## AO-IN-2023-029-I

### Introduction of improved carrier tape for Chip LED SFH 2705

06.06.2023

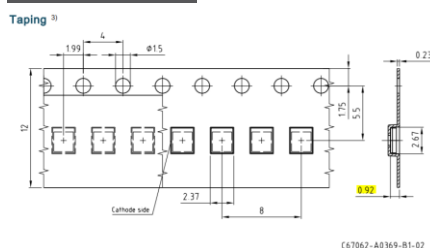
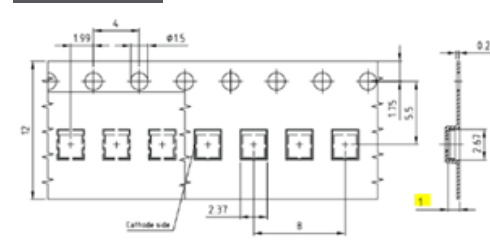
**Reason for change:** Improvement of carrier tape design to harmonize with other Chip LED products.

Current status

Pocket depth – 0.92mm

New status

Pocket Depth – 1.00mm

**Time schedule:** The improved carrier tape will be in use from date code 2329 onwards.

**Assessment:** No change in fit, form, function and reliability of the product.  
The tape drawing will be updated in the datasheet.
